Float Pond Working Group

RUNWAY SAFETY ACTION TEAM

- ◆ Action Code Item: FAI-2018-001
- ◆ Melissa Osborn, FAI Operations Director asked GAA to form a working group to look at the issues raised.
- ◆ Make a recommendation.

KEY ISSUES

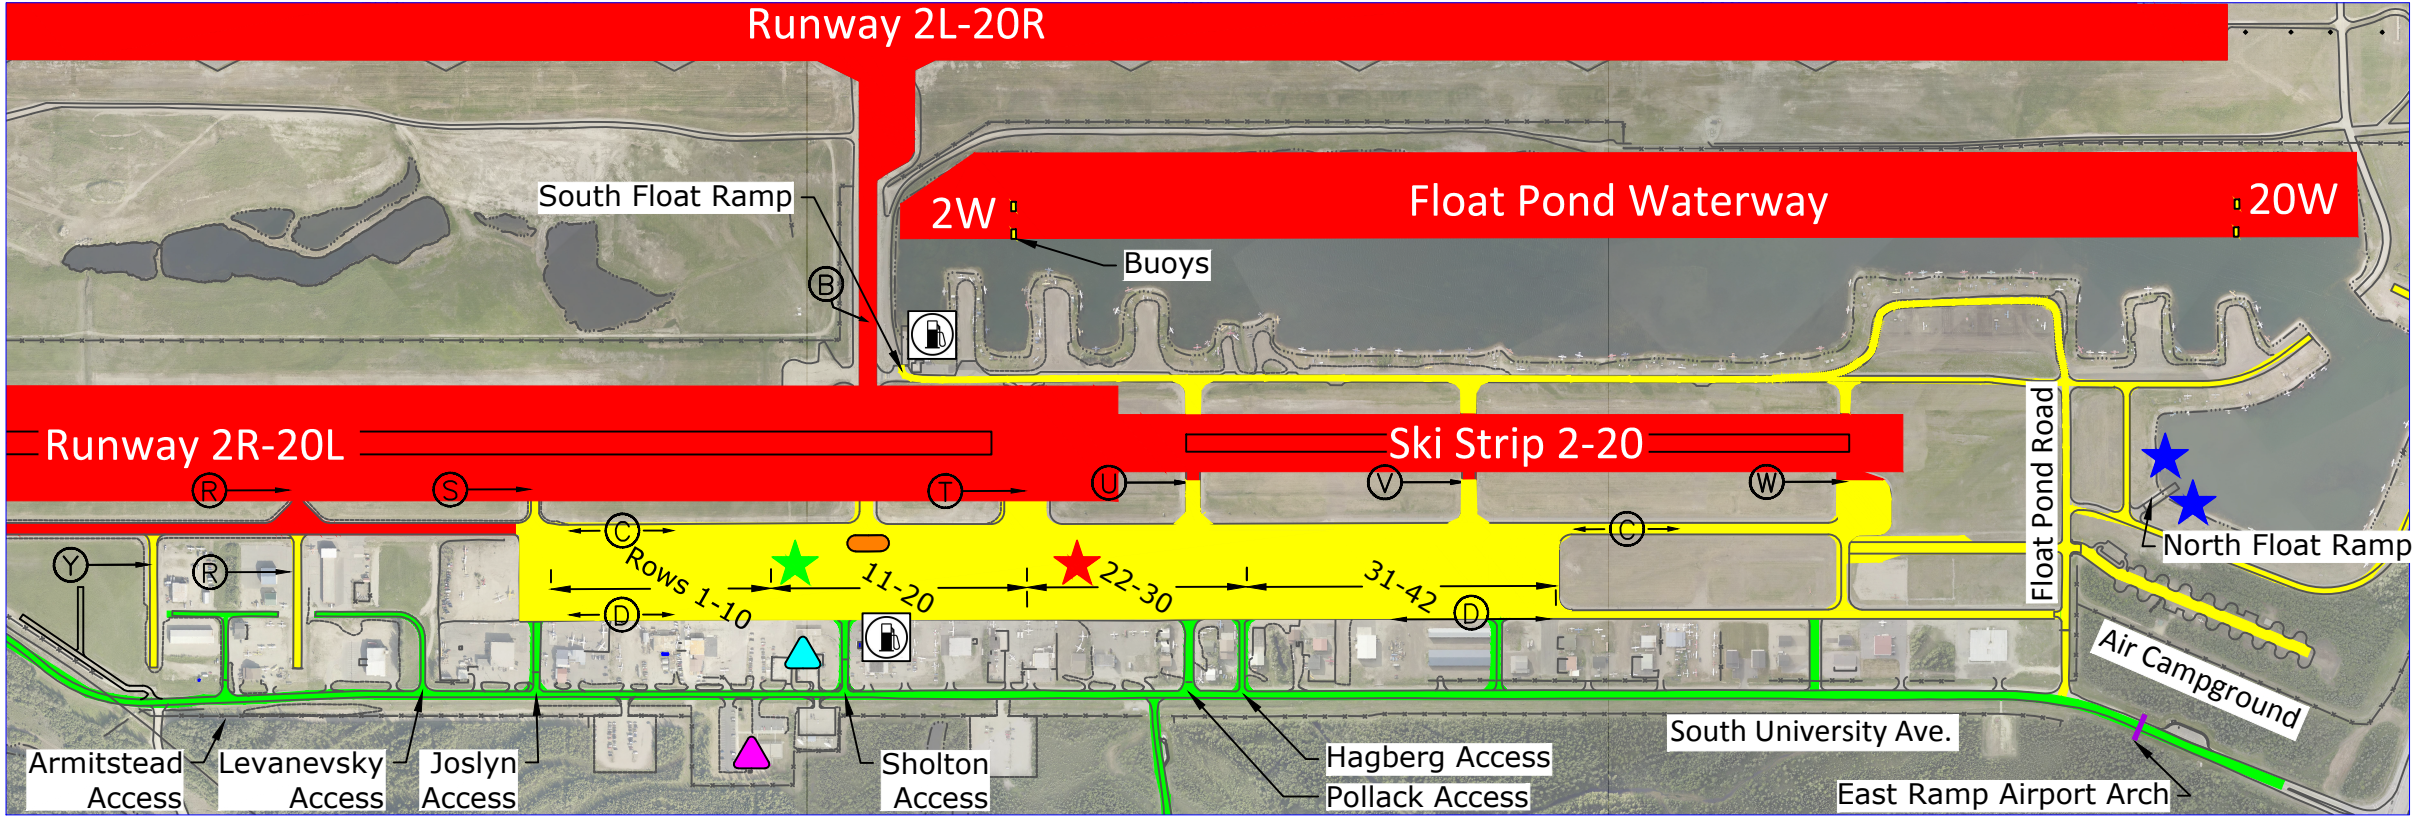
4. Consider testing a prominently visible marker on the south and north bank aligned with the eastern most buoys to provide visual assistance to help pilots determine the line between "controlled" and "uncontrolled" surfaces.
